UNITED STATES PATENT AND TRADEMARK OFFICE

Office Action Summary	Application No. 10/553,383	Applicant(s) PARK ET AL.	
	Examiner DNYANESH KASTURE	Art Unit 4147

The following title is suggested: Swash plate driven double head compressor with motor cooling.

Fig. 1

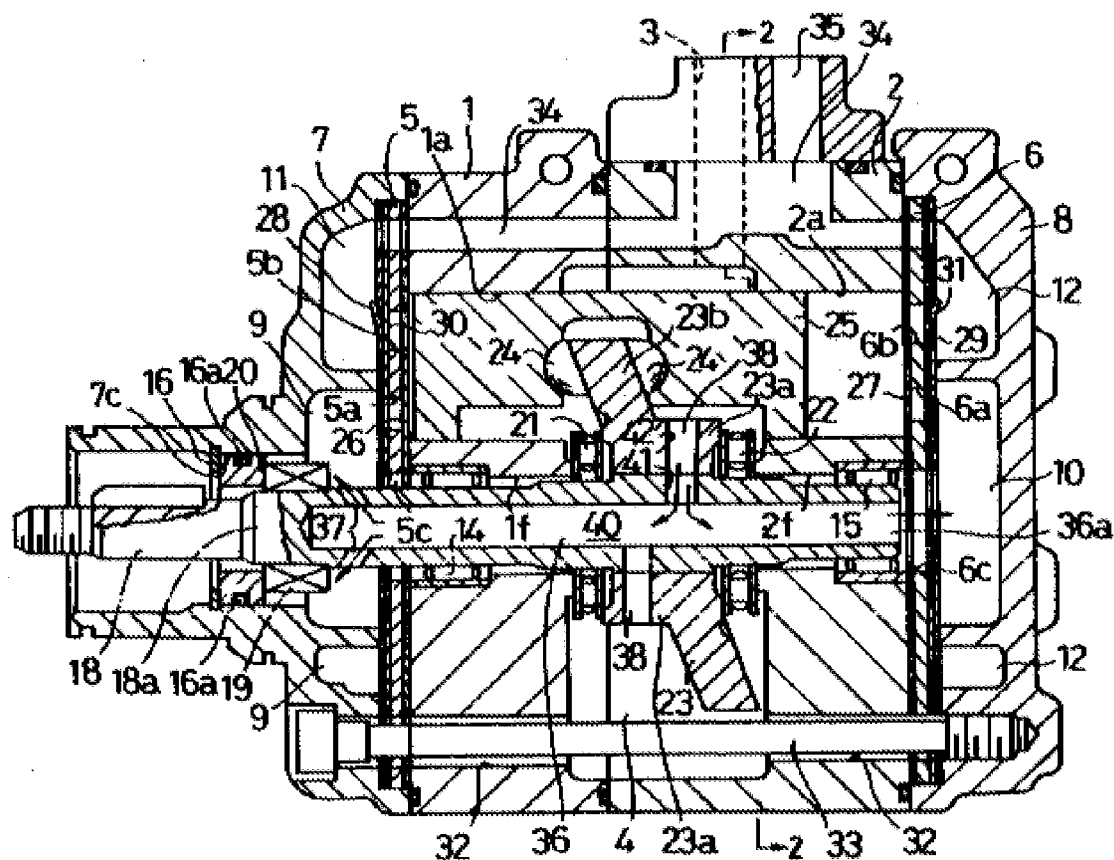
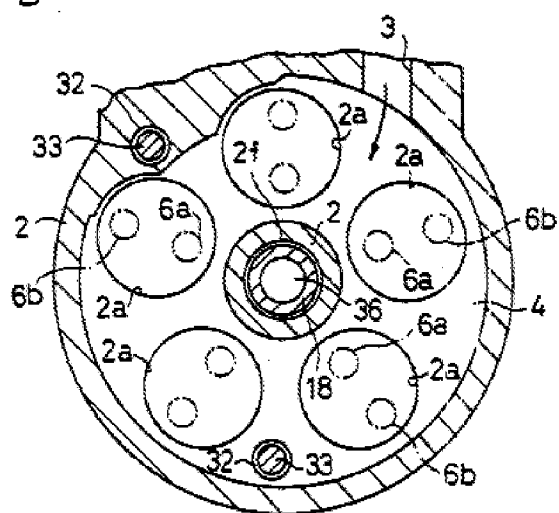
12. In Re claim 12, with reference to figures 1 and 2, Fujii et al discloses a compressor installed to one side of driving means (not depicted) that provide drive to shaft (18), the compressor unit comprises:

- a front housing (7) having discharge chamber (11)
- a rear housing (8) having a suction chamber (10) inherently partitioned from a discharge chamber (12), with a discharge port (35) formed at one side communicating through discharge passage (34) with the discharge chamber (12)
- a cylinder block (1), (2) coupled between the front housing (7) and the rear housing (8) and having a plurality of bores (1a), (2a) formed at both sides (1a) and (2a) of the swash plate chamber that is inherently formed within cylinder blocks (1), (2) and a refrigeration suction port (3) formed at one side thereof

- a swash plate (23) placed in the swash plate chamber and coupled with drive shaft (18), and a plurality of double head pistons (25) (Column 3, Line 25) for reciprocating within the bores (1a), (2a) in cooperation with the rotation of the swash plate (23)
- feeding means (38), (40), and (36a) for feeding refrigerant from the swash plate chamber partially into the suction chamber of the rear housing (10). With regards to “..means for feeding refrigerant..”, this limitation meets the three prong test per MPEP 2181 and thereby invokes 35 USC 112 6th paragraph. The means for feeding refrigerant has been disclosed in Figure 5 of applicant's drawings.

Fig. 5

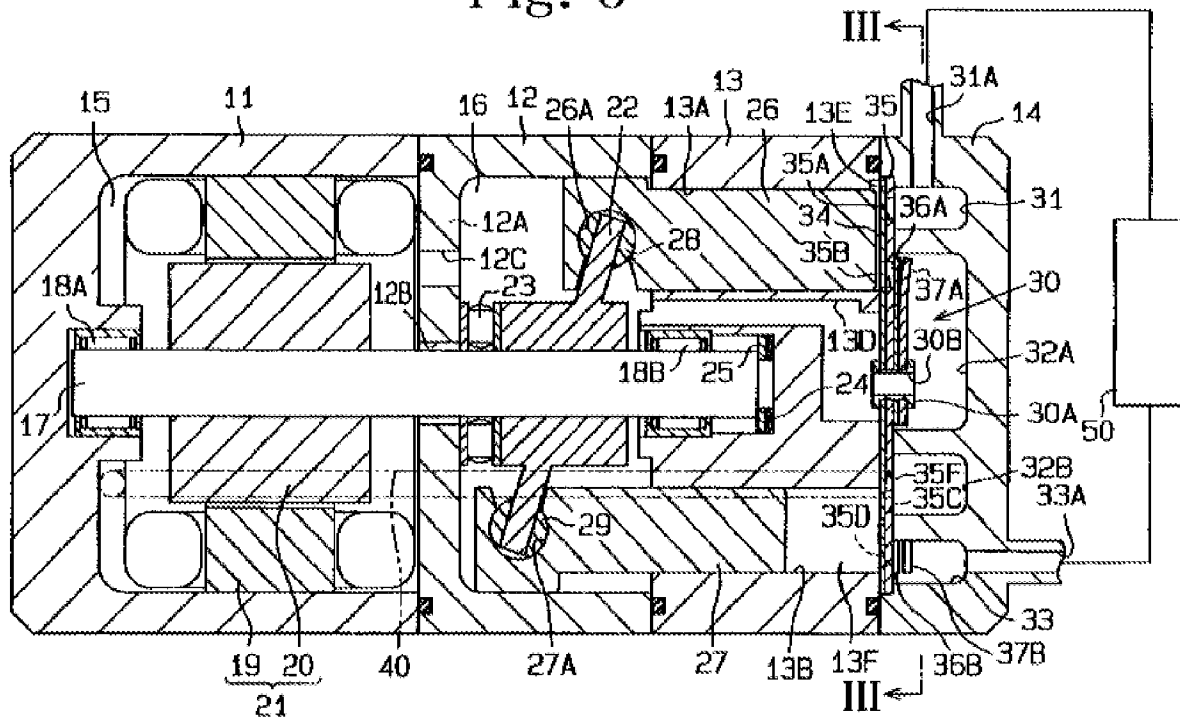
14. Nevertheless, with reference to Figure 5, Yokomachi et al discloses a motor driven compressor unit comprising:

- a motor unit (11) comprising an electric motor (21) installed in an inside motor room (15) for rotating a drive shaft (17)

- a compressor unit installed to the right of motor unit (11) as depicted, the compressor unit comprising:
 - a front housing (12)
 - a rear housing (14) having chamber (32B) inherently partitioned from a discharge chamber (33), with a discharge port (33A) formed at one side communicating with the discharge chamber (33)

- a cylinder block (13) coupled between the front housing (12) and the rear housing (14) and having a plurality of bores (13A), (13B) formed at both sides (13A) and (13B) of the swash plate chamber (16) and a refrigeration suction port (31A) formed at one side thereof

- a swash plate (22) placed in the swash plate chamber (16) and coupled with drive shaft (17), and a plurality of double head pistons (26), (27) for reciprocating within the bores (13A), (13B) in cooperation with the rotation of the swash plate (22)

- feeding means comprising communication bore (12C) and central bore (12B) for feeding refrigerant from the swash plate chamber (16) partially into the motor room (15). With regards to “..means for feeding refrigerant..”, this limitation meets the three prong test per MPEP 2181 and thereby invokes 35 USC 112 6th paragraph. The means for feeding refrigerant has been disclosed in Figure 5 of applicant's drawings.

- the front housing (12) further has a suction passage (40) for communicating the motor room (15) to the bore (13B) through intermediate pressure chamber (32B) to allow the suction of refrigerant supplied to the motor room (15) into the bore (13B). In addition, there is another suction passage communicating the bore

(13A) to the motor room (15) originating at the bore (13A), through chamber (30), hole (30B), communication bore (13D) and communication bore (12C) in the front housing (12) leading into the motor room (15).

Fig. 4

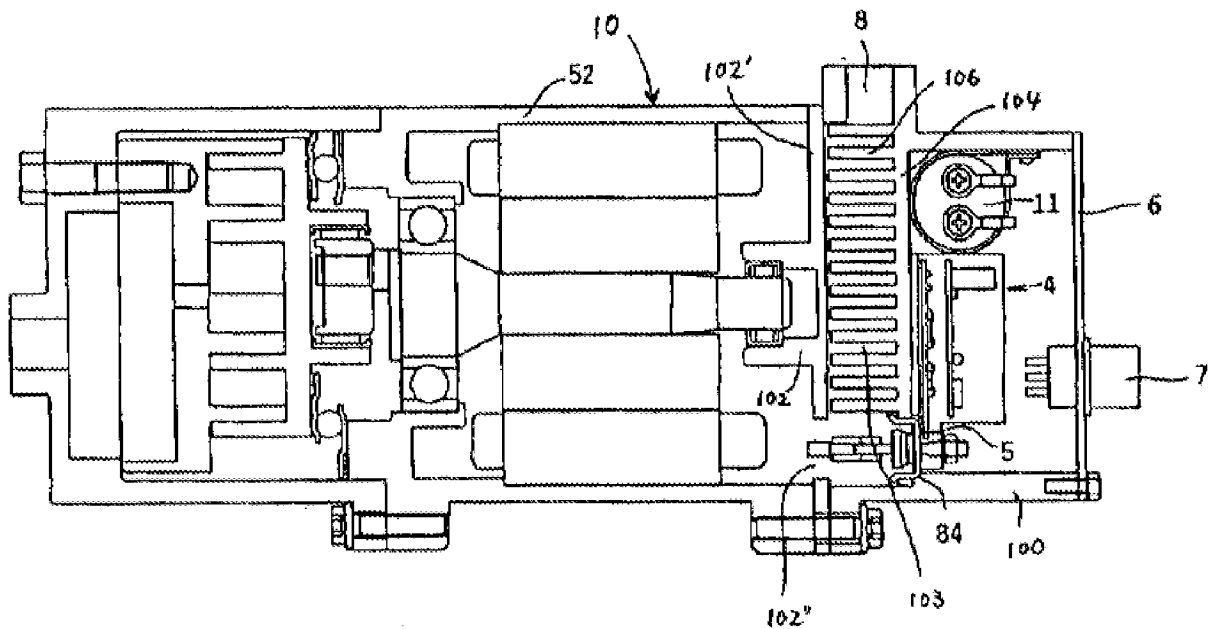
24. However, with reference to Figure 4 depicted above, Saito et al discloses a suction muffler chamber (100) formed at one side of cylinder block (52), the suction muffler chamber (100) is mounted with motor controlling means (4) on an upstream section (103) where refrigerant is introduced through inlet port (8).

26. In Re claim 21, Saito et al discloses the motor controlling means (4) comprises an inverter (2) as mentioned in Paragraph [0033].
